AR-22-007

April 28, 2022

Re: Comments on the Proposed Arkansas Regional Haze Planning Period II State Implementation Plan

Figure 1. History of Bank Prime Rate, Aug. 8, 1983 to Mar. 17, 2022

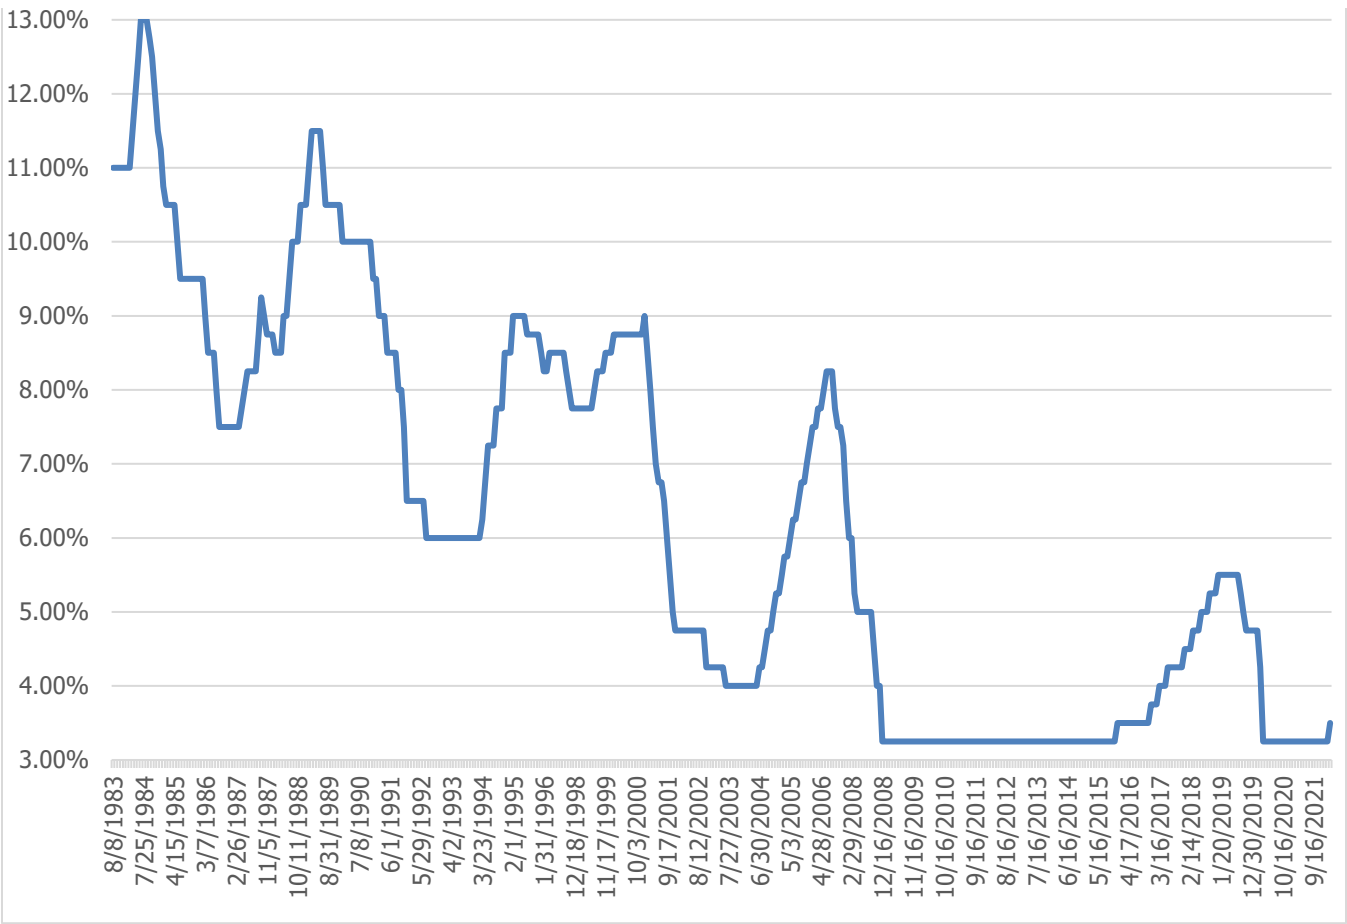
5. Although Entergy supports the conclusion that DEQ reached with respect to Independence—that further controls should not be required for the second planning period based on cost considerations—Entergy does not support one aspect of DEQ’s cost evaluation. Specifically, DEQ should not use 3.25 percent – the bank prime rate at the time of the SIP proposal – for capital recovery calculations for the sources evaluated for potential reasonable progress controls. *See, e.g.,* proposed SIP at V-20 and V-21. As discussed in the Texas Commission on Environmental Quality’s *Response to Comments Received Concerning the 2021 Regional Haze State Implementation Plan (SIP) Revision* (herein referred to as the “TCEQ RTC”), “[u]sing the bank prime rate in the four-factor analysis would not reflect **real** costs expected to be imposed on selected sources.” TCEQ RTC at 23-24, emphasis added.

Moreover, even if the bank prime rate were representative of actual costs in real time, DEQ’s use of a rate from a fixed point in time—the rate established during the first two years of the Covid 19 pandemic—is already outdated and there is no guarantee that it will not change further before costs are realized several years in the future. As illustrated in Attachment 1, the bank prime rate has fluctuated significantly over the years. The rate was 4.75 percent as recently as October 2019, but then dropped to 4.25 percent on March 3, 2020, and then to 3.25 percent on March 15, 2020. The March 2020 rates resulted from emergency Covid 19 measures initiated by the Federal Reserve, first, on March 3, 2020, when it lowered interest rates by half a point, and, second, on March 15, 2020, when it dropped interest rates to zero to one-quarter point.¹⁰ Recently, however, the bank prime rate increased from 3.25 percent to 3.5 percent as a result of actions by the Federal Reserve and it is possible that the rate could rise again after the Federal Reserve’s next meeting on May 4, 2022.

Based on the history of the bank prime rate, the unprecedented amount of inflation in 2021 and 2022, and current worldwide economic pressures, it is inappropriate to rely upon a bank prime rate set due to conditions related to the Covid 19 pandemic for capital recovery calculations. Entergy, in its Four-Factor Analysis for Independence, provided support for using an interest rate of seven percent in calculating costs. Entergy maintains that seven percent is a more appropriate number given the history of the bank prime rate. At the least, DEQ should use a historical average to establish the interest rate used for capital recovery calculations but specifically *exclude* from that average the artificially low 3.25 percent bank prime rate resulting from the Federal Reserve’s emergency Covid 19 measures.
